MODEL
XK
(X150)

NUMBER
JTB00038

TECHNICAL BULLETIN

Console Ashtray Operation

Figure 1

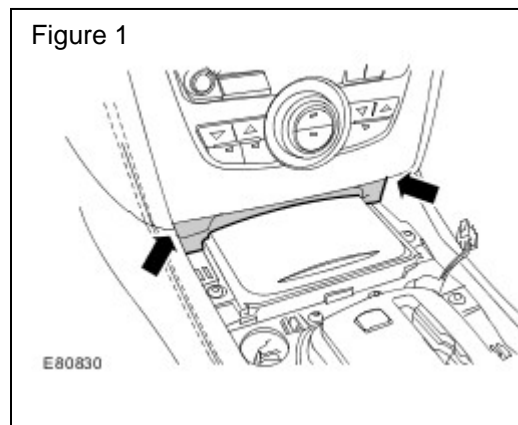
CAUTION: To avoid damage to the components, the hooked screwdriver, or suitable tool, must be carefully inserted as high up the ashtray cover panel as possible when releasing the clips to remove the ashtray cover panel. (Arrowed in Figure 1)

3. Using a thin hooked screwdriver, or suitable tool, release the two clips securing the ashtray cover panel. (Arrowed in Figure 1)
4. Remove the ashtray cover panel.
5. Check operation of ashtray lid.
6. If the ashtray lid operation 'noise' has disappeared or the 'slow' operation has been resolved, modify the ashtray cover panel as follows:
 - Select a suitable fine file.
 - Lightly file along the lower edge of ashtray cover panel, removing only enough material to allow smooth operation of the ashtray lid. (Figure 2)
7. Install the ashtray cover panel.
8. Verify that the lid operates properly and no noise is present.
9. If no other symptoms are present, refer to GTR Workshop Manual, Section: 501-12 (76.47.26) and install the floor console veneer panel.

Figure 3

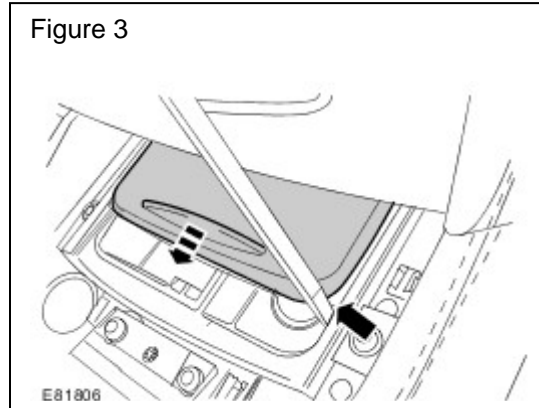
1. If the ashtray lid will not **remain open**, refer to GTR section 501-12 operation 76.47.26 and remove the floor console veneer panel.
2. Using a thin screwdriver, or suitable tool, hold the ashtray lid a quarter of the way open. (Solid arrow in Figure 3)

3. Pull the veneer towards the rear of the vehicle to release the four securing clips. (Dashed arrow in Figure 3)
4. Slide the ashtray lid veneer panel off to remove.

Figure 4

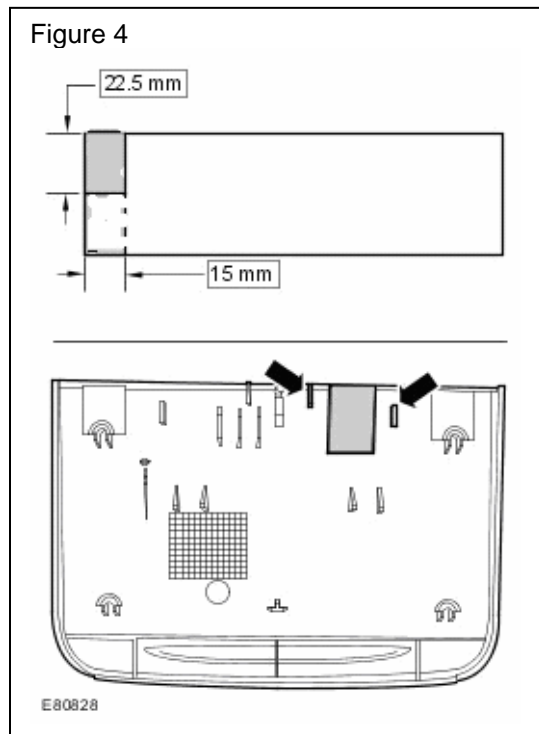
5. Check operation of ashtray lid.
6. If the ashtray lid latches, perform the following:
 - Cut a piece of foam pad to the dimensions 22.5 mm x 15 mm (0.9 in. x 0.6 in.) as illustrated. (Shaded in Figure 4)

- Apply the foam pad to the back of the ashtray lid veneer between the tabs as illustrated. (Arrowed in Figure 4)
 - Slide the ashtray lid veneer panel onto the ashtray lid to install.
